STAFF REPORT
COMMUNITY DEVELOPMENT DEPARTMENT

HEARING DATE: 03/18/2025
TO: Mayor & City Council
FROM: Nick Napoli, Associate Planner
208-884-5533
SUBJECT: Brundage Estates Subdivision No. 1
FP-2024-0024
LOCATION: Generally located east of S. Linder Road
midway between W. Victory and W.
Amity Roads, in Section 25, Township 3,
Range 1 West.

Final Plat consisting of 29 residential building lots and six (6) common lots on approximately 11.62 acres of land in the R-4 zoning district by L.C Development.

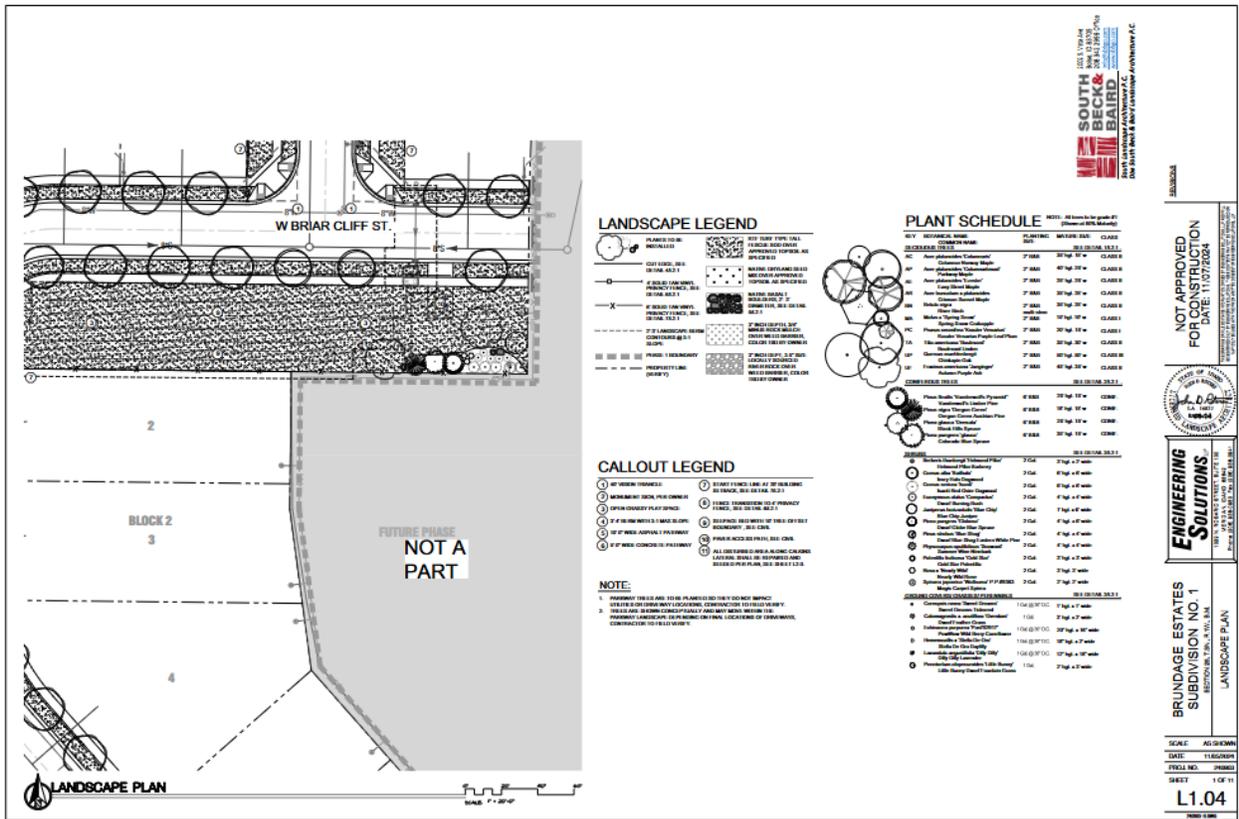
- Note #10: Include the recorded instrument number of the Development Agreement.
 - Note #12: Include the recorded instrument number for the ACHD license agreement.

- Note #13: Include the recorded instrument number for Ada County.
 - Note #15: Include the recorded instrument number of the Development Agreement.

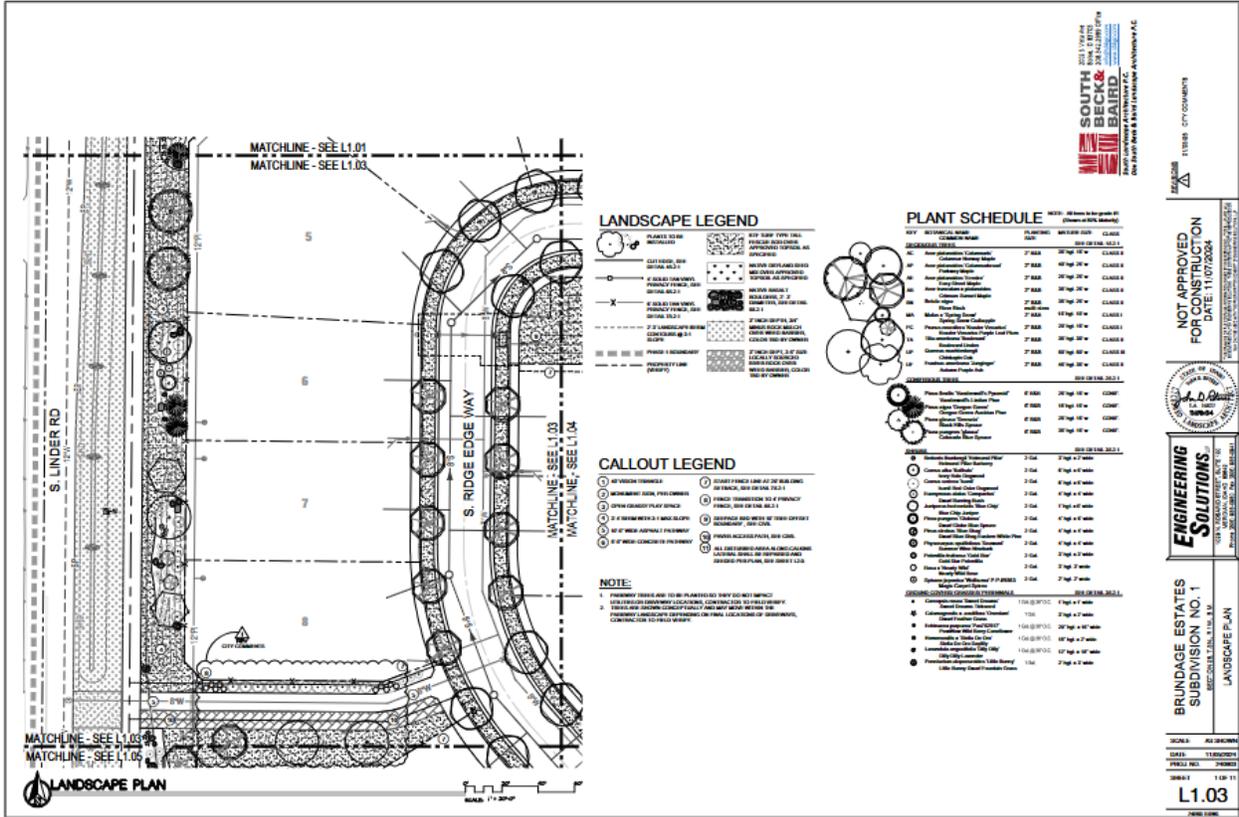
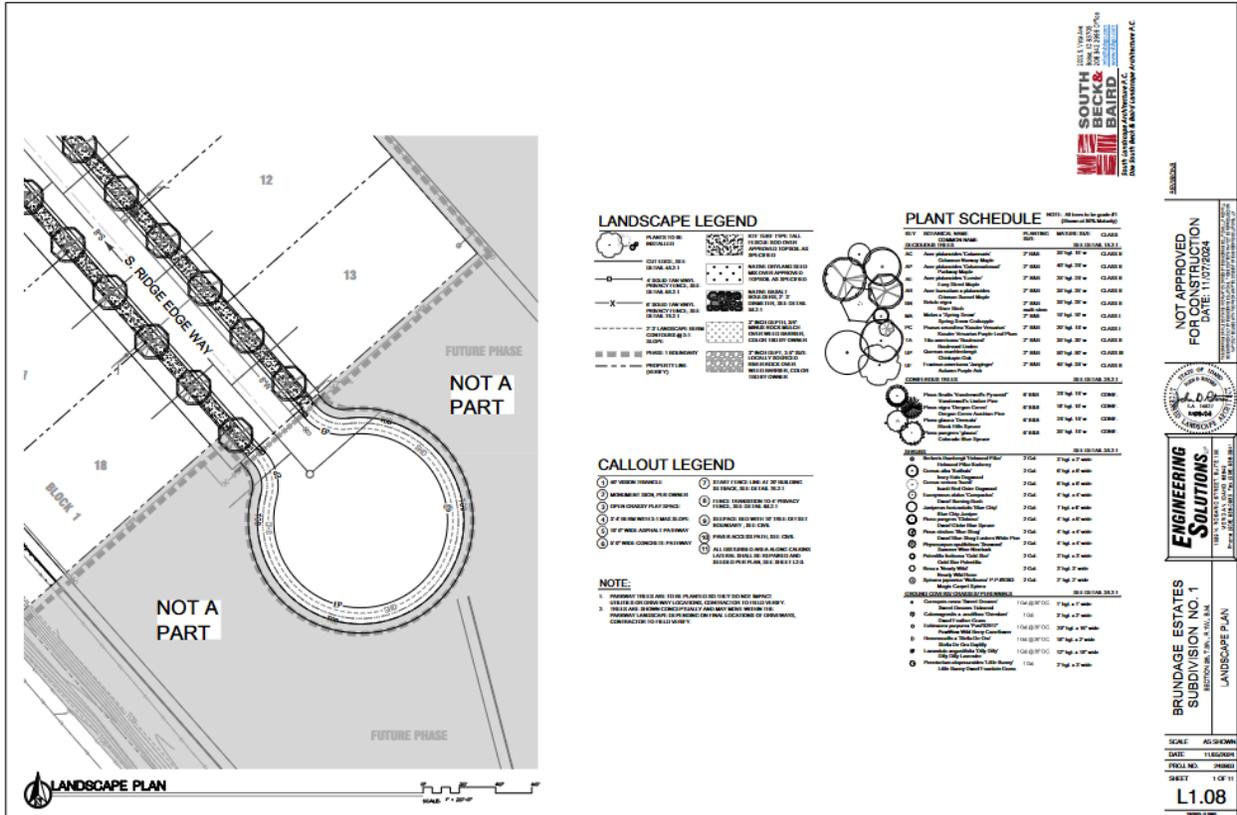
5. The landscape plan shown in Section V.C, dated 11/05/24, shall be revised as follows:
 - Include mitigation calculations on the plan for existing trees that are proposed to be removed in accordance with the standard listed in UDC 11-3B-10C.5.

- Depict and dimension the 10-foot multi-use pathway that has been rerouted in front of Lots 9-18, Block 1. *NOTE: With a future phase, this pathway must extend and connect with the pathway location on the east side of the Calkins Lateral approved with Windrow Subdivision.*

- Add vegetation coverage that meets UDC 11-3B-7 requirements on the west side of the ten (10) foot multi-use pathway along S. Linder Road. A 10-foot gravel shoulder is allowed to remain, but the rest must be vegetated in accord with UDC 11-3B-7-5.
